TRUMAN AVE
NEW COMMERCIAL BUILDINGS & TWO
RESIDENTIAL UNITS
 KEY WEST, FL

DRAWING NAME
LANDSCAPE PLAN & DETAILS

STAFF REPORT

RE: **1028-1030 Truman Avenue (permit application # T18-9140)**

1 LANDSCAPE PLAN
SCALE: 1"=10'-0"

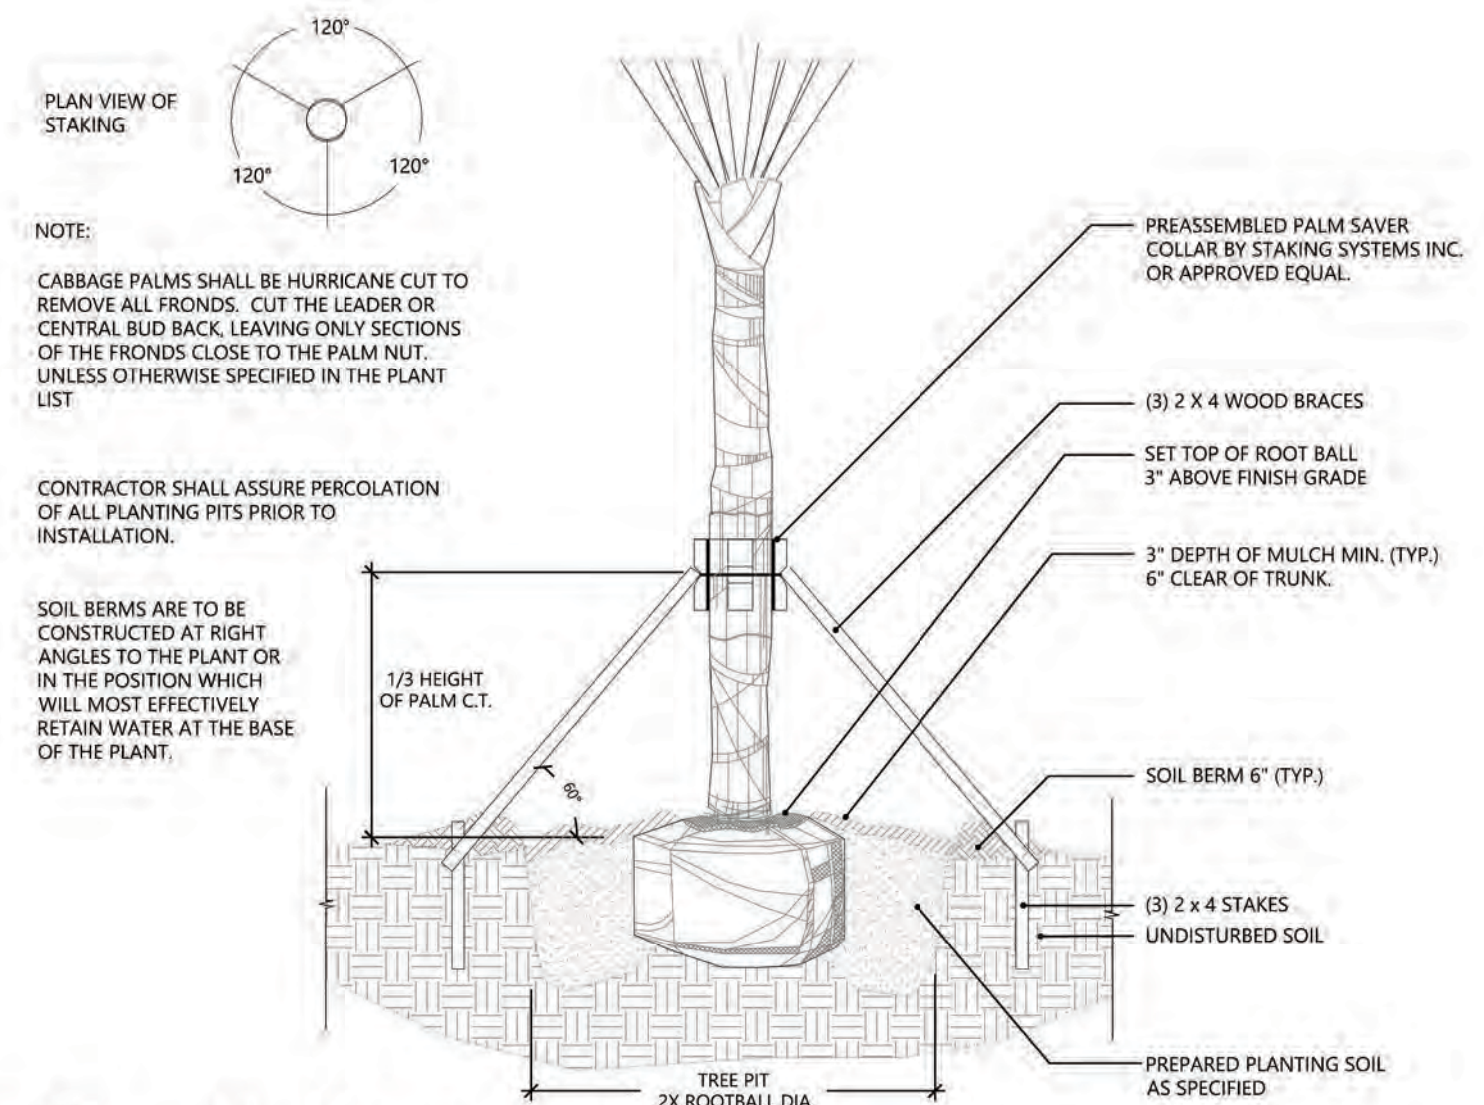
An application was received for Landscape Plan Approval for a Minor Development Plan. The property is currently a vacant lot with no trees. There are two tree planters in the right of way/sidewalk area, a live Satinleaf tree and a dead tree. The right of way is controlled by the State of Florida.

In 2016, the existing structure on the property was demolished. In order to successfully demolish the structure, a satinleaf tree in the right of way needed to be removed. The requirement for the removal of the tree was to plant replacements on the property including a tree for the planter. Besides the Satinleaf that currently exists in the right of way planter, (2) Simpson Stopper shrubby trees were planted in the rear corners of the lot. Those trees are not currently present on the property and need to be replaced. Therefore, either (2) Simpson Stopper shrubby trees or a total of 4.1 caliper inches of trees needs to be incorporated into the landscape plan.

The Landscape Plan submitted does incorporate all the required tree removal replacements (1-Blackbead and 2-Buttonwood trees). It does not appear that the plan represents 70% native vegetation/species but most of the species are common in the Florida Keys area.

Please note that there used to be two simpson stopper trees on each rear corner of the property a year ago. Not sure what happened to them as the hurricane should have had no impact. Those young trees were planted to fulfill a tree replacement requirement and I expect them to be replanted or replaced in the landscaping.

FYI--the satinleaf tree in the sidewalk planter was also part of that required replacement.
